PREVOST

WARRANTY BULLETIN

WB23-37

DATE:	December 2023	SECTION:	06 ELECTRICAL
EXPIRATION:	December 2025		
SUBJECT:	WIPER MOTOR HARNESS MODIFICATION

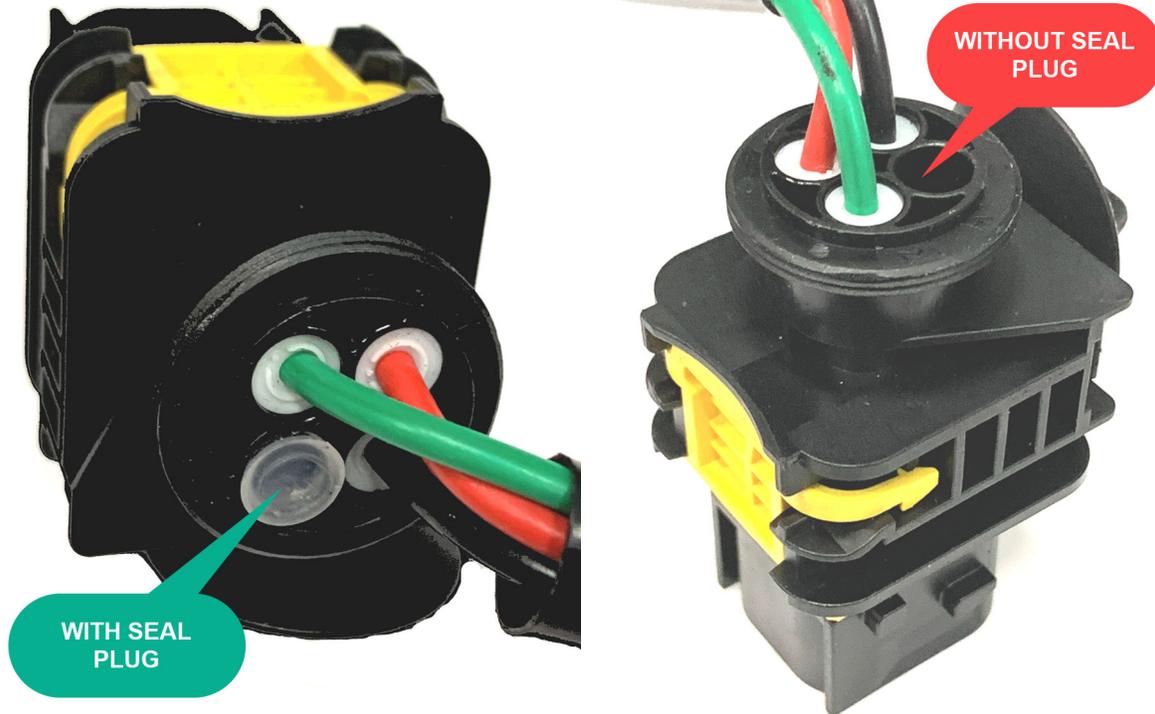
5. Verify if the connector has a plug into the empty cavity.
- If no, go to the next step.
 - If yes, the procedure is complete.

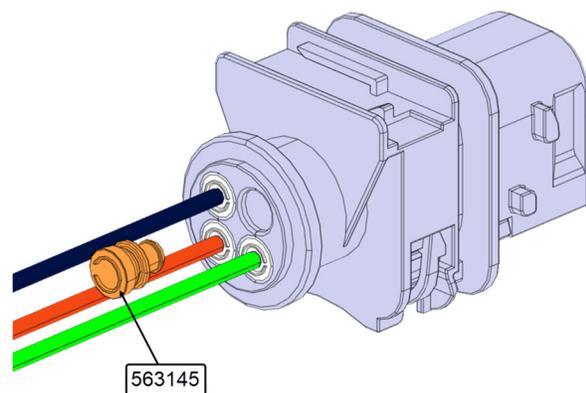
6. Add cavity plug 563145 to connector empty terminal hole.
